Supply of Electric Meters for EDTL

(IFB No.: ICB/002/EDTL-2013)

Clarification - 1 in Bidding Documents

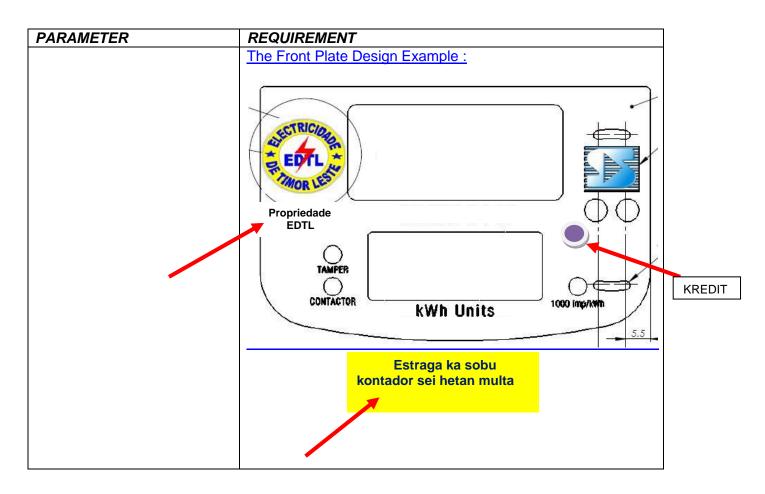
Question #12: Also can you assist to clarify what is the information that I need to input under

"Addenda No." (e.g: in the "Technical Proposal Submission Sheet") there is a

line indicating "Addenda No."

Answer #12: This refers to any Addendum in bidding documents (if any) issued by the

Purchaser during the bidding period. If there is no Addendum in bidding

documents issued, just state "None".
